**THE REGIONAL MUNICIPALITY OF YORK
ADDENDA # 4
T-19-16**

FOR: Construction of Paramedic Response Station No. 29 at 107 Glen Cameron Road in the City of Markham

ARCHITECTURAL ADDENDUM 02

York Region Paramedic Response Station #29
107 Glen Cameron Road, Markham

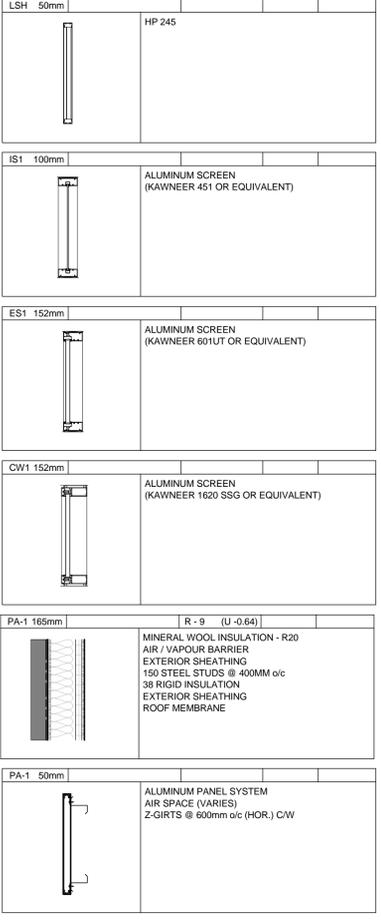
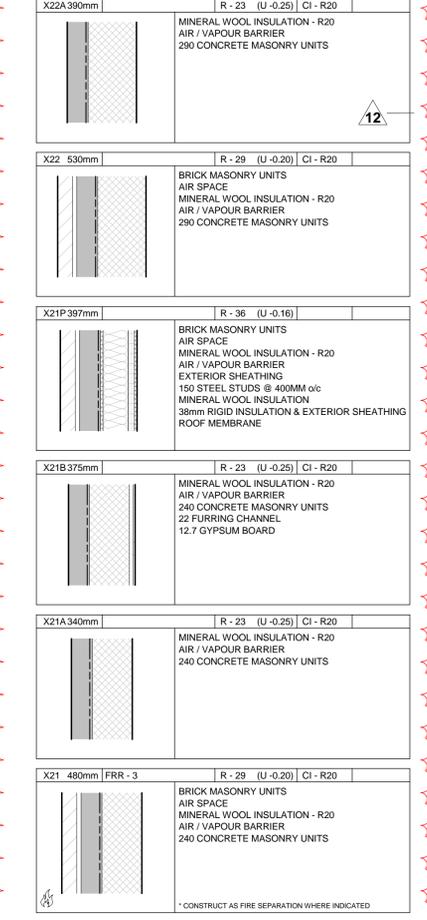
Q11 Please clarify what “CBU” means on Partition Type P5 & P8 on Drawing 4/A0.2. Abbreviation list on same drawing sheet indicates Concrete Block Unit. Please clarify.

- .1 Replace and insert revised detail 1 and detail 8.
- .3 Replace and insert revised detail for Partitions P5 and P8.
- .4 Replace and inset revised details for X22A, X22, X21P, X21B, X21A, X21.

A Refer to attached revised Partition Type P5 & P8 on drawing A0.2 Assemblies, Schedules, and Notes.

DRAWING No: A1.3 REVISION: 12

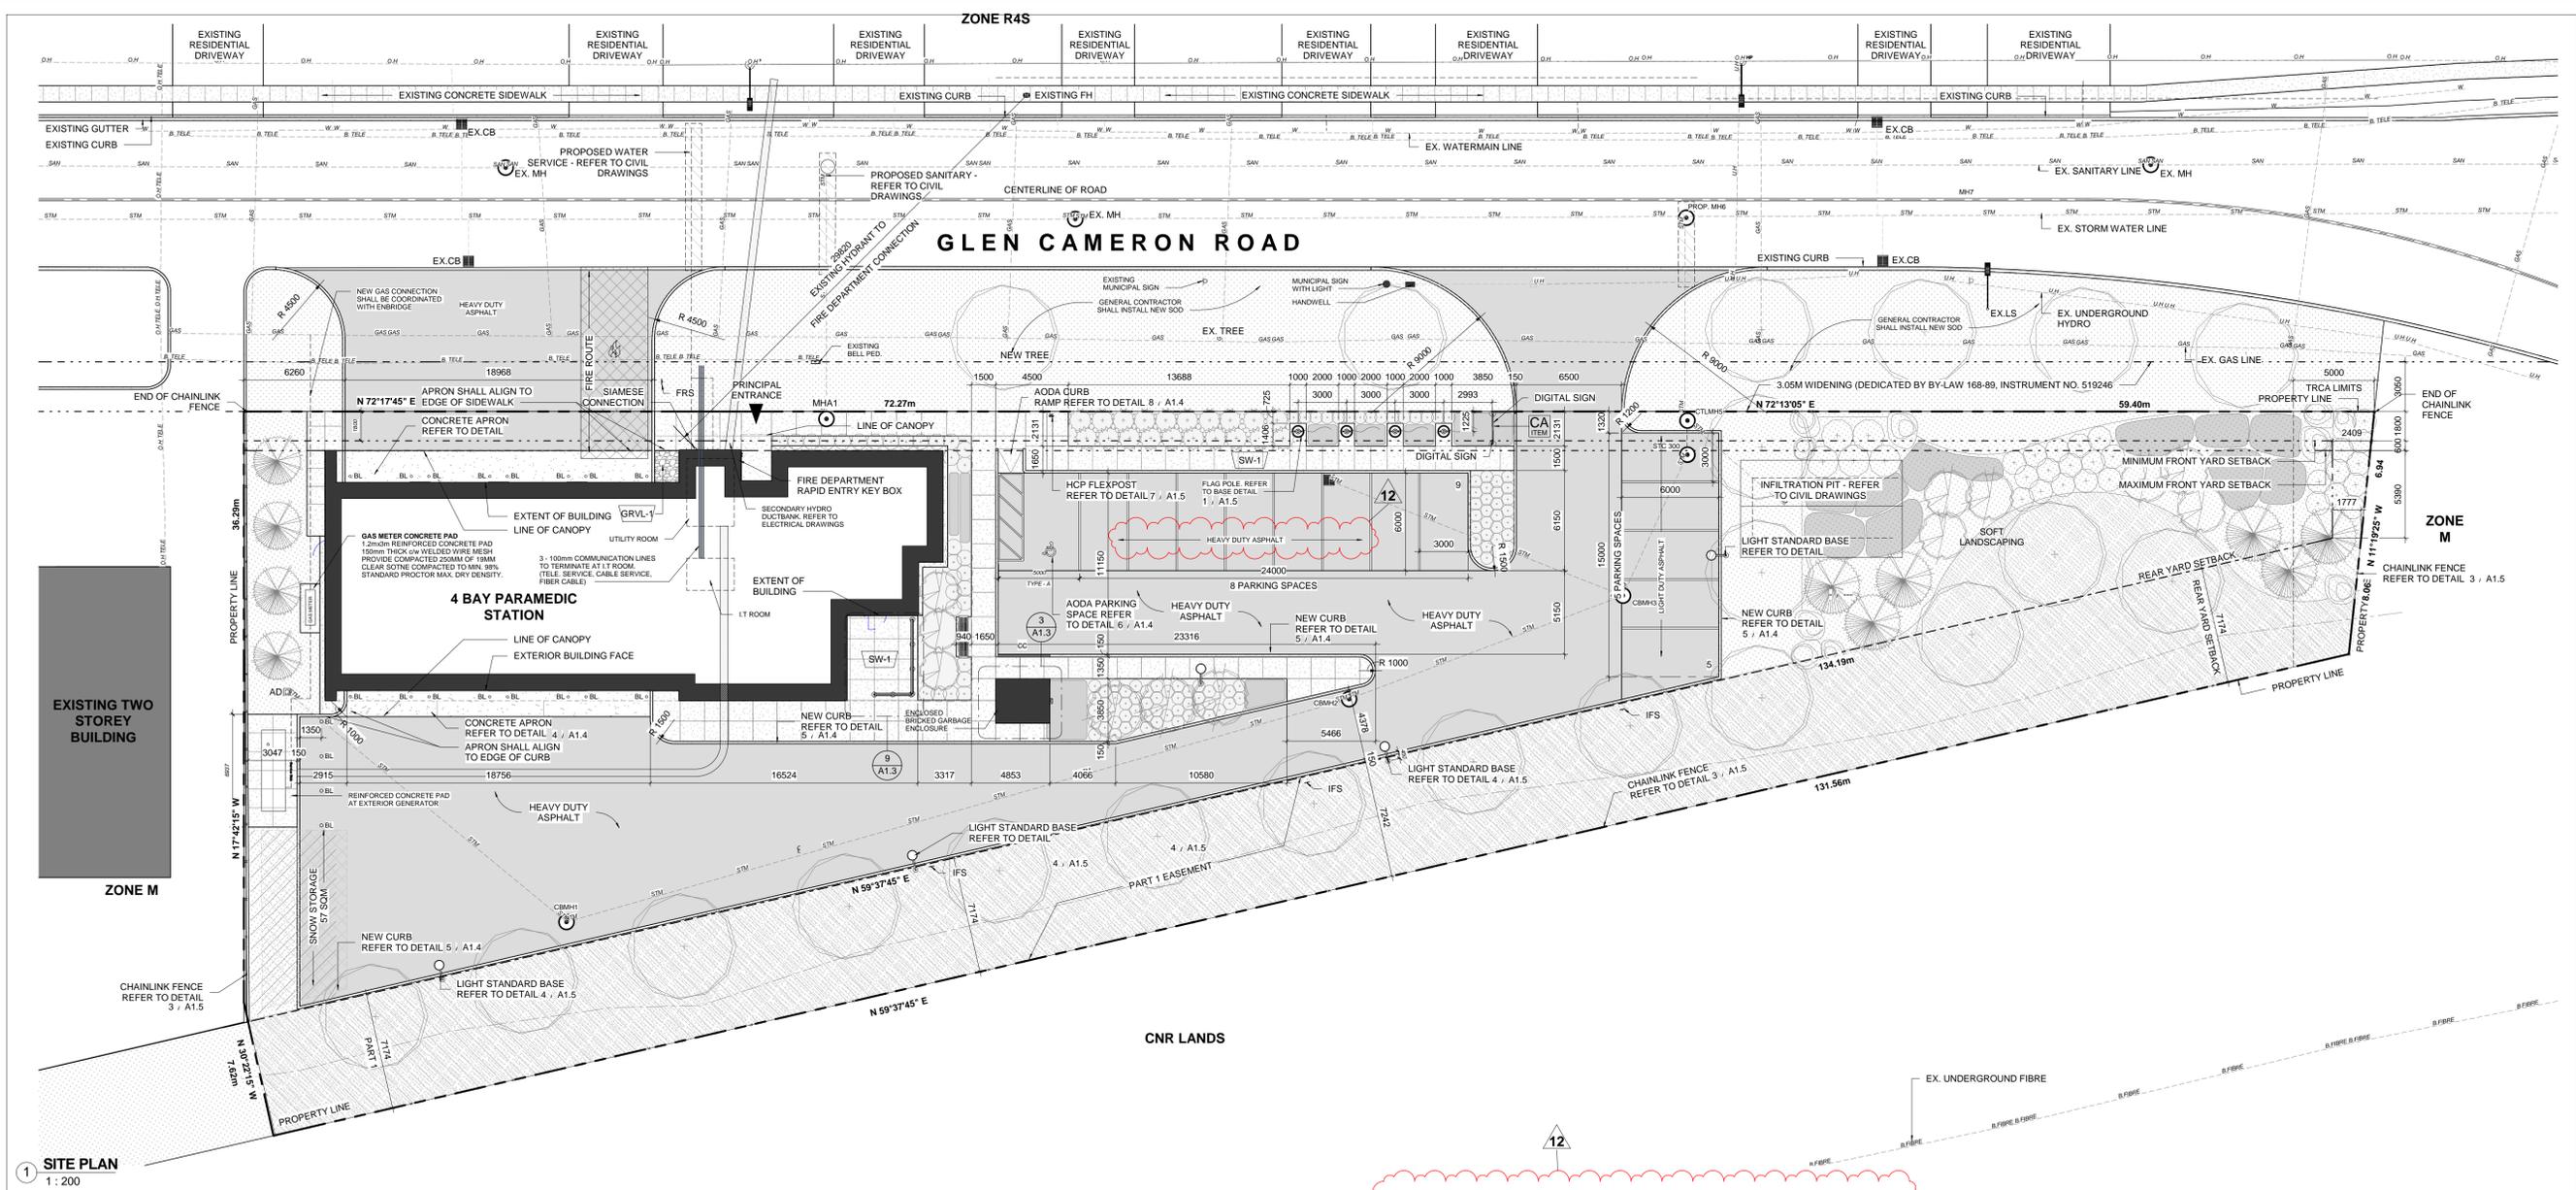
Can you please have the consultants confirm if all asphalt paving on site is to be heavy duty paving? The Grading Plan shows all asphalt to be heavy duty. The site plans shows the parking stalls to be light duty. Drawing A1.4 only indicates a heavy-duty detail leading us to believe only heavy-duty paving is required on site. Please clarify and provide details for light duty asphalt if required.

- .1 Revise note "Light Duty Asphalt to read "Heavy Duty Asphalt".
- .2 Replace and insert revised detail 2.

A All asphalt shall be Heavy Duty.

DRAWING No: **A2.1** REVISION: 12

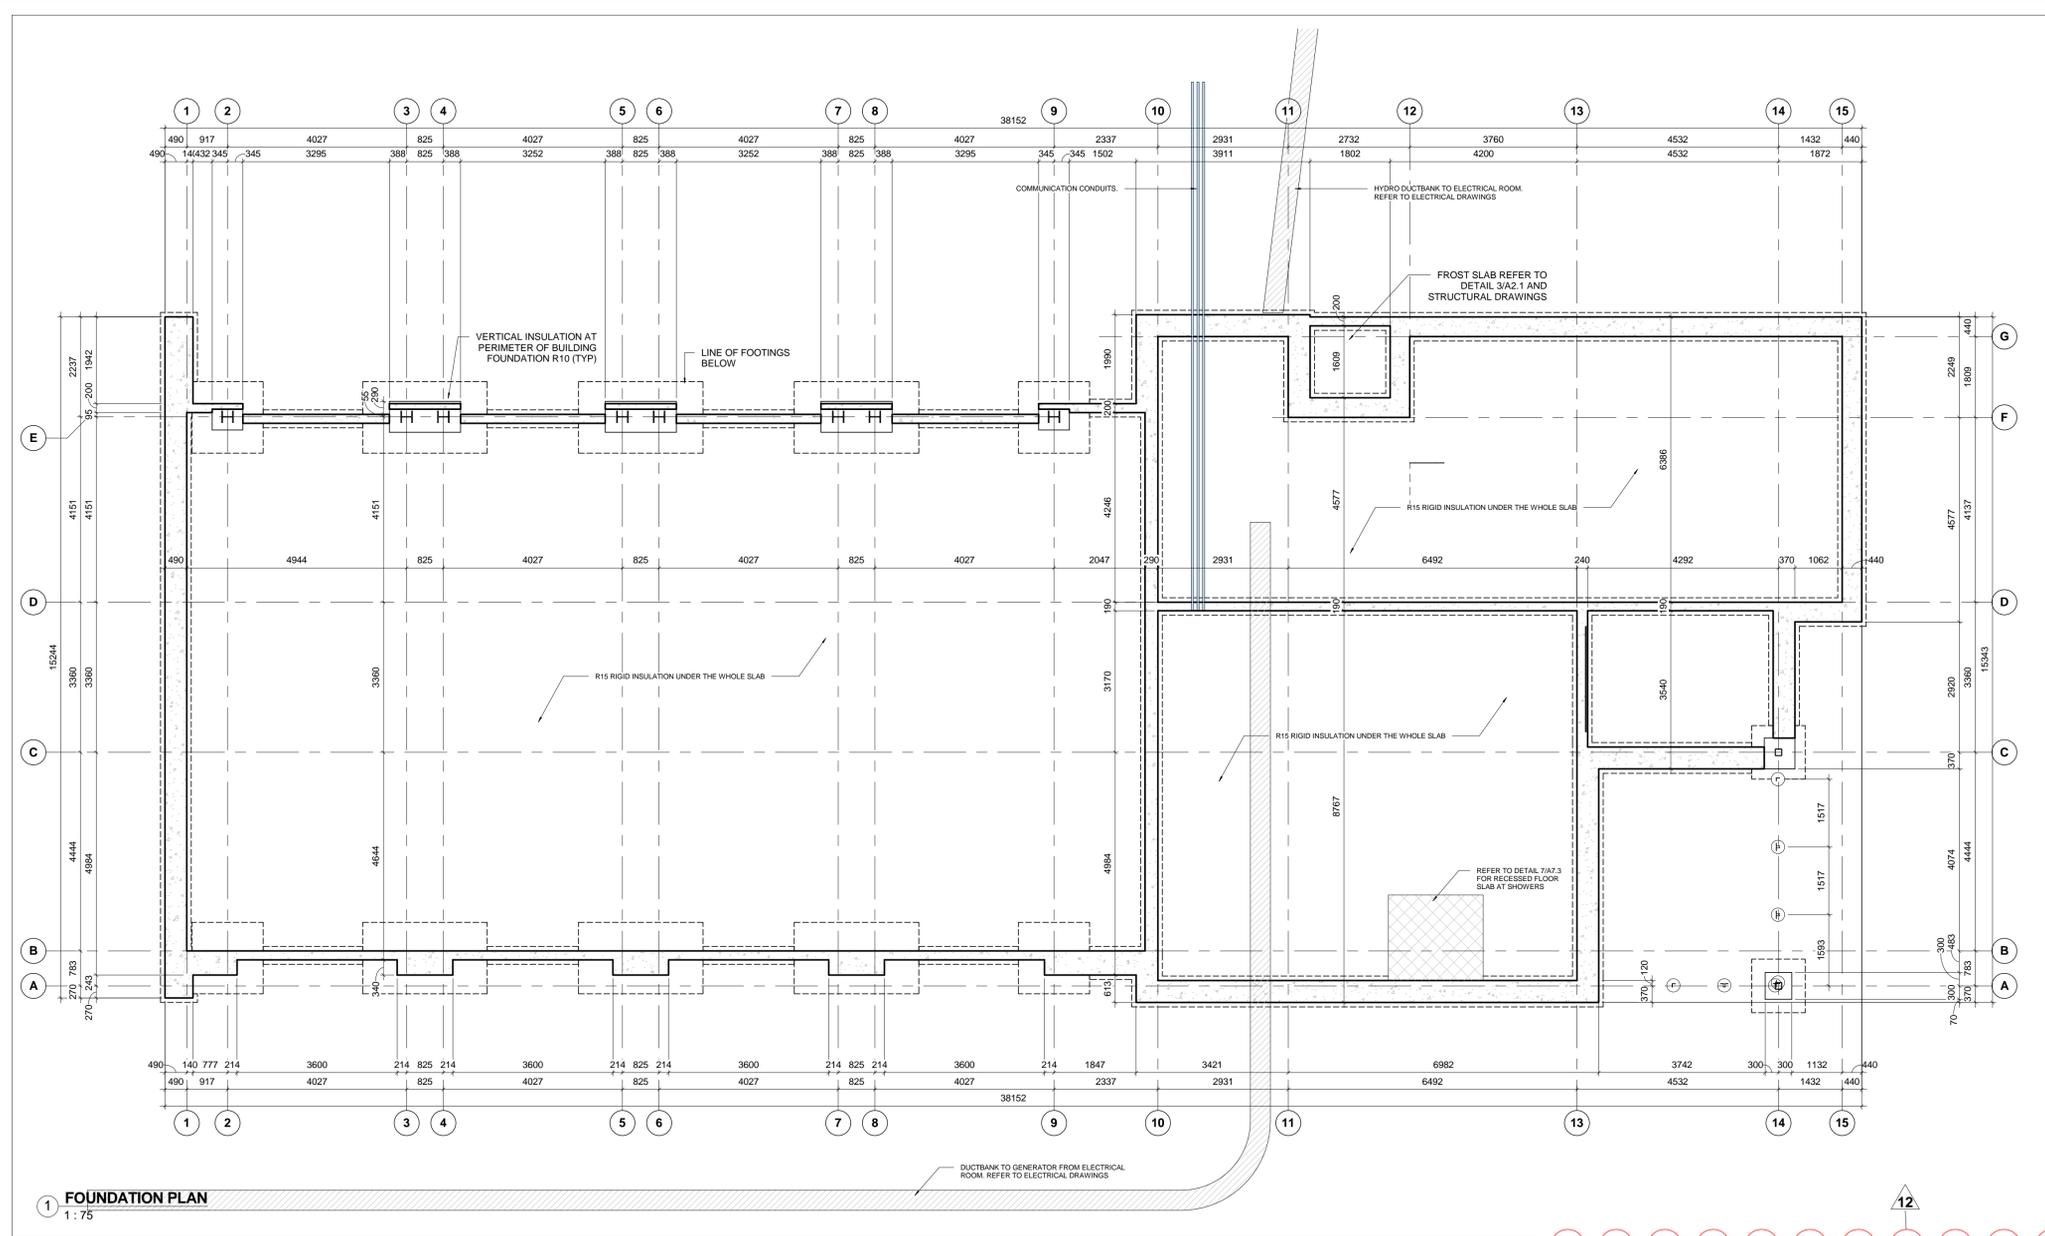
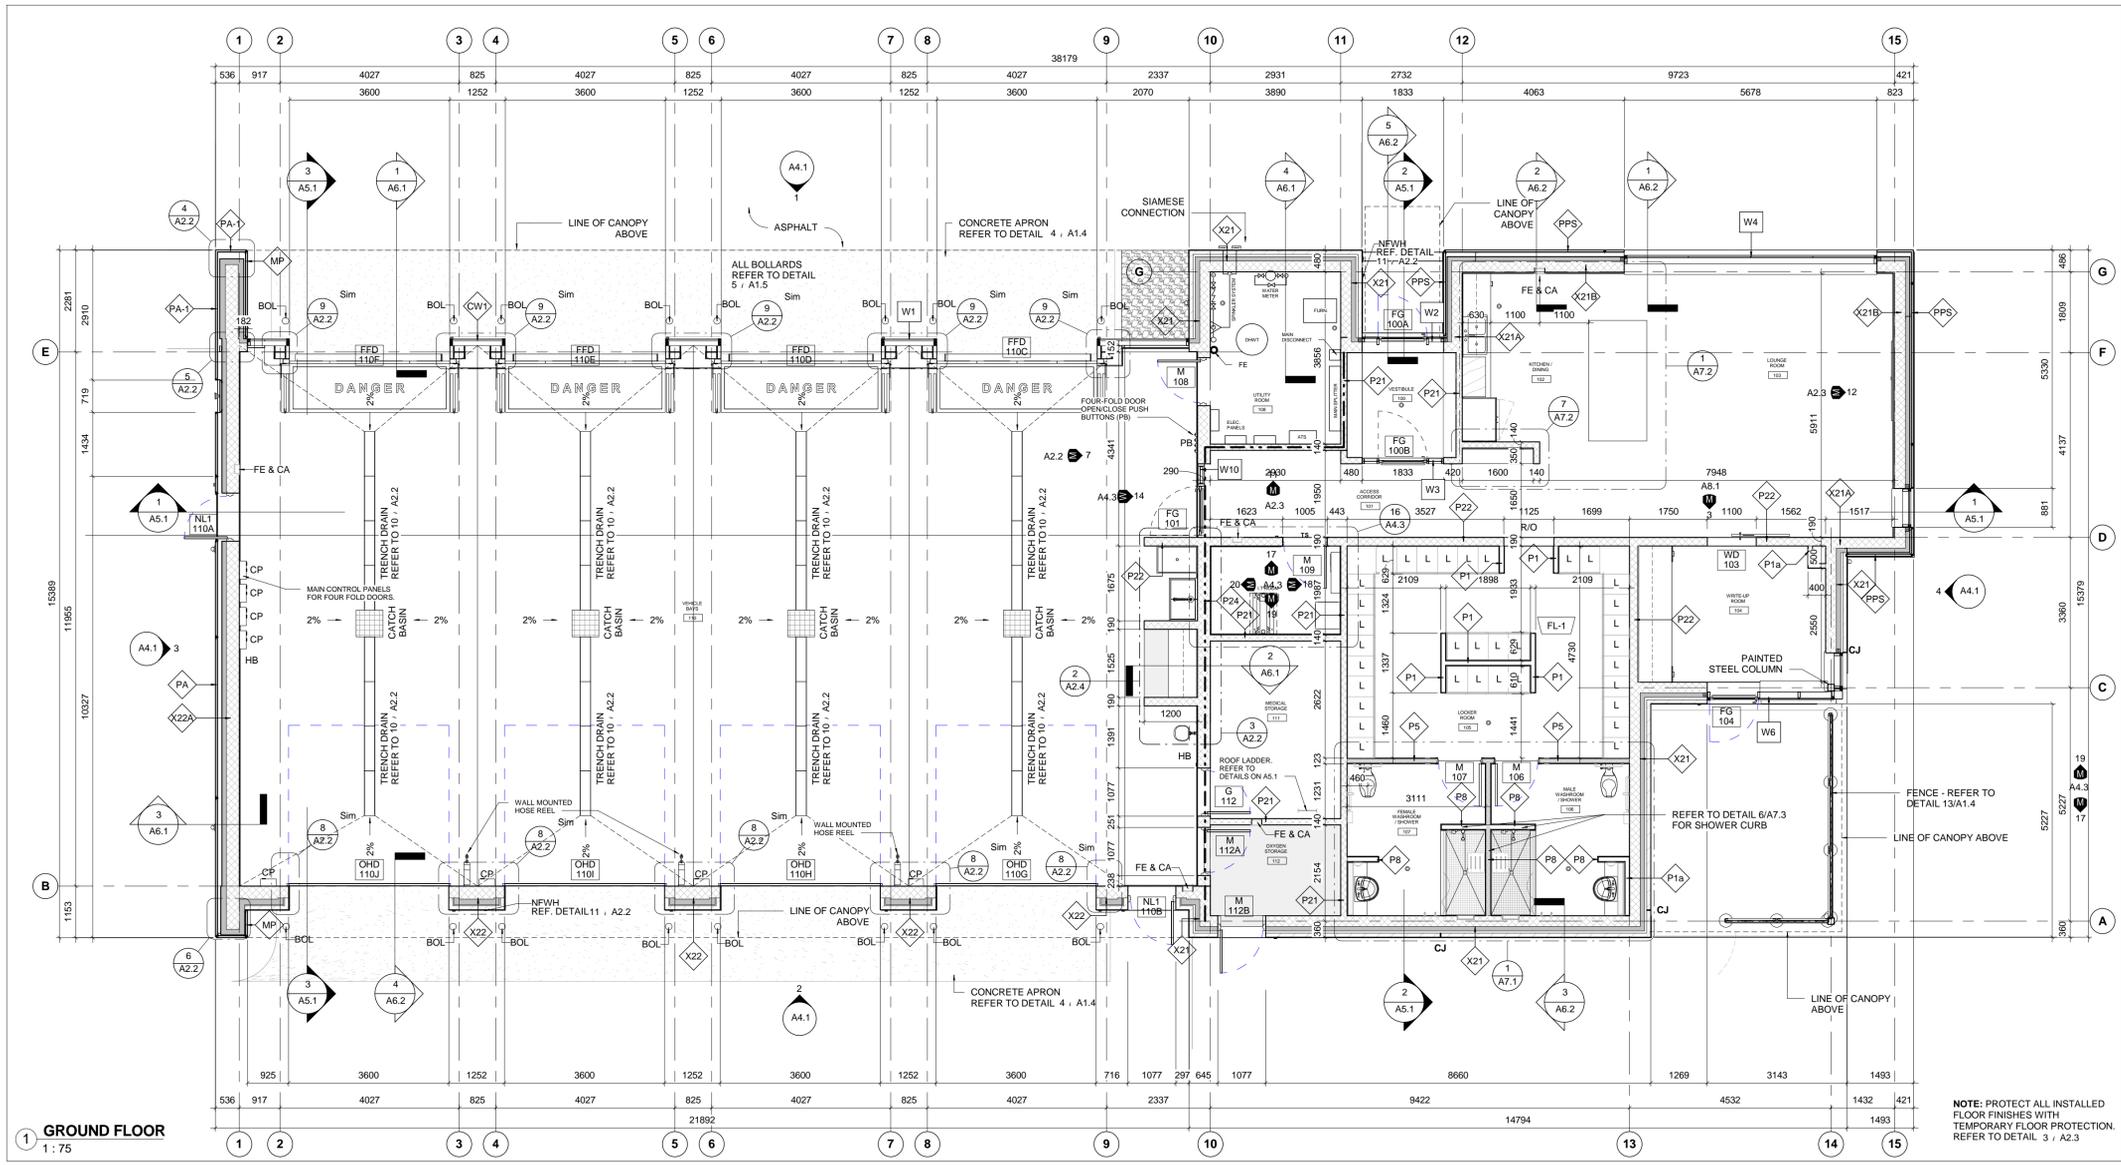
-
- Q1** Please provide specification/detail for the generator pad shown on drawing A1.3.
- A** Refer to Architectural Addendum 1, Question No. 9
- Q2** Please provide thickness of rigid insulation to the u/s of SOG as shown on drawing A2.1.

- .1 Replace and insert revised detail 2.

- A** To meet the intent of the drawings, the rigid insulation is indicated by the R-Value. Contractor shall install appropriate thickness to achieve the R-Value indicated.

1 ROOF PLAN
1:75

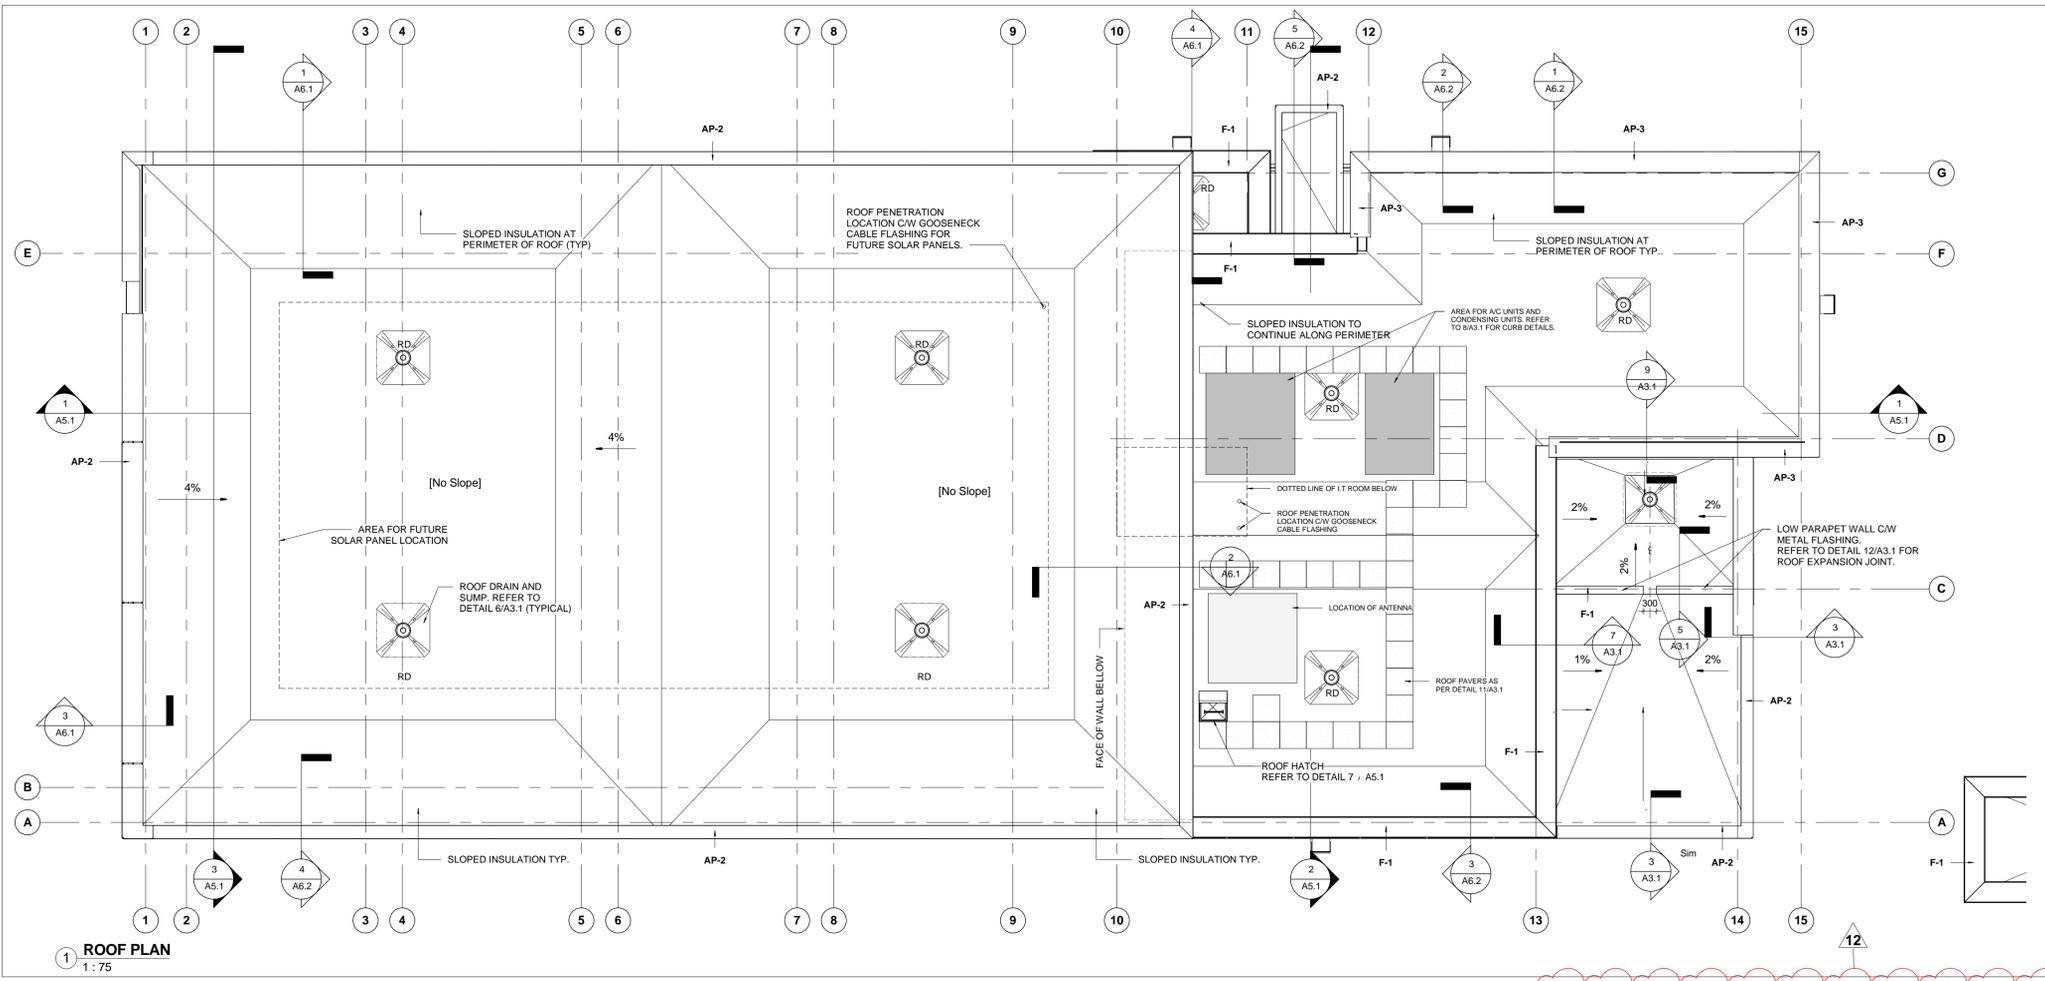
- .1 Replace and insert revised detail 2.
